**PCN#20200629000.1A****Qualification of new Fab site (RFAB) using qualified Process Technology, Die Revision, and additional Assembly site/BOM options for select devices****Change Notification / Sample Request**

**Date:** August 07, 2020  
**To:** MACNICA (DSTR) PCN

<b>PCN Number:</b>	20200629000.1A	<b>PCN Date:</b>	Aug 7, 2020
<b>Title:</b>	Qualification of new Fab site (RFAB) using qualified Process Technology, Die Revision, and additional Assembly site/BOM options for select devices		
<b>Customer Contact:</b>	<a href="#">PCN Manager</a>	<b>Dept:</b>	Quality Services
<b>Proposed 1<sup>st</sup> Ship Date:</b>	Sept 27, 2020	<b>Estimated Sample Availability:</b>	Date provided at sample request.
<b>Change Type:</b>			
<input checked="" type="checkbox"/>	Assembly Site	<input checked="" type="checkbox"/>	Assembly Process
<input checked="" type="checkbox"/>	Design	<input type="checkbox"/>	Electrical Specification
<input type="checkbox"/>	Test Site	<input type="checkbox"/>	Packing/Shipping/Labeling
<input type="checkbox"/>	Wafer Bump Site	<input type="checkbox"/>	Wafer Bump Material
<input checked="" type="checkbox"/>	Wafer Fab Site	<input checked="" type="checkbox"/>	Wafer Fab Materi

Sample product shipping label (not actual product label)

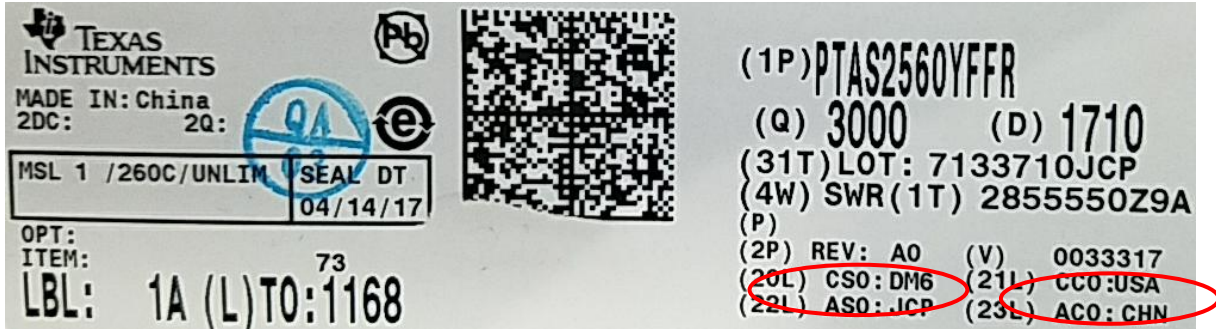
**Changes to product identification resulting from this PCN:**

**Die Rev:**

<b>Current</b>	<b>New</b>
Die Rev [2P] E, G, K, or T	<b>Die Rev [2P]</b> <b>B</b>
